UNITED STATES PATENT AND TRADEMARK OFFICE

APPLICATION NO.	FILING DATE	FIRST NAMED INVENTOR	ATTORNEY DOCKET NO.	CONFIRMATION NO.
09/648,588	08/25/2000	Michel Lesimple	10767-002001	6960

Office Action Summary	Application No. 09/648,588	Applicant(s) LESIMPLE, MICHEL	
	Examiner Charles E. Cooley	Art Unit 1723

DETAILED ACTION

FIG. 2

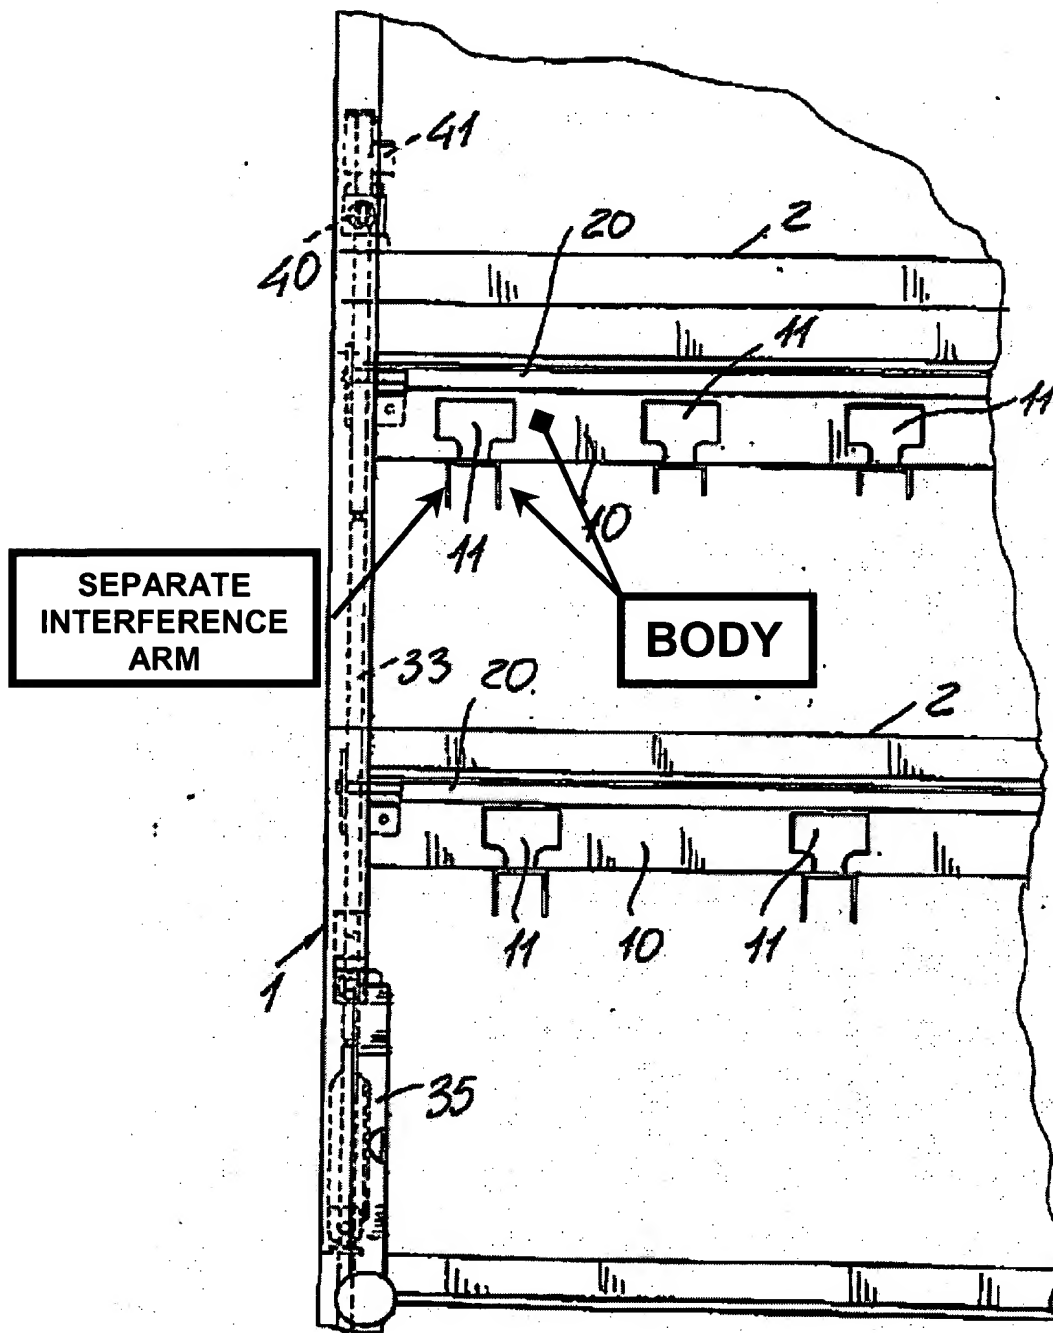
IT 1250630 discloses a system for stirring paint in an insertable can comprising a container/can 3 with a can cover and a stirrer within the can having a drive shaft (below 4); a can support shelf 2 below the can; an individual stirring head (which may be used with a single can or multiple cans which is nothing but an intended use not germane to patentability) positioned above the shelf that engages the stirrer to rotate the stirrer in the can when the can is inserted on the shelf, the stirring head comprising a body 10 (the element 10 and one of the downwardly depending flange members below 11 - as labeled in Figure 2 below) carrying a rotational stirrer drive mechanism (such as the pulley and depending drive shaft seen in Fig. 4); said body being shaped to trap the cover in position when the can is inserted on the shelf so that the drive shaft of the stirrer in the cover is drivingly aligned with the rotational drive mechanism in the stirring head (see Fig. 4); said body further including a separate interference arm (the left hand separate element seen below 11 in Fig. 3 and below 12 in Fig. 4 and as labeled in the Figure below) extending from above the location of the can downwardly toward the shelf that prevents rotation of the cover as the stirrer rotates within the can by mechanically interfering with the can cover as seen in Figs. 4-5; the stirrer in the can including a drive shaft which protrudes from the can cover as seen in Figs. 4-5; an engaging member 12 extending from the stirring head 10 which engages an upper portion of the drive shaft as seen in Figs. 4-5; a region between the stirring head and the shelf being free of obstructions as seen in Figs. 4-5; the head 10 is connected to a hollow shelf (another one of 2) arranged above the can cover as seen in Figs. 4-5; the shaft portion including a plate 4 with upwardly extending fingers and the engaging member 12 being a driver

with a blade actuatable with the fingers to effect rotation and the engaging member 12 engages the plate with fingers as seen in Figs. 4-5; the interference arm being a single arm assembly (e.g., the U-shaped arm seen in Fig. 3) or conversely being two downwardly extending arms (the two vertically disposed planar arms seen below 11 in Fig. 3); the can cover including a spout and the interference arm engages the spout as seen in Figs. 4-5; the shelf 2 being free of pins as clearly seen in the Figures.

NOTE FIGURE 2 of IT '630 below:

With regard to the second matter, the element shown equivalent to the "separate interference arm" in Figure 2 above is a rotation preventing arm or flange that is a discrete and separate member (note "separate" is considered a very broad term) from the element 10 and the other laterally spaced and downwardly depending arm or flange

member. The examiner fails to see any difference between the subject matter of amended claim 29 and the four corners of the IT '630 reference.
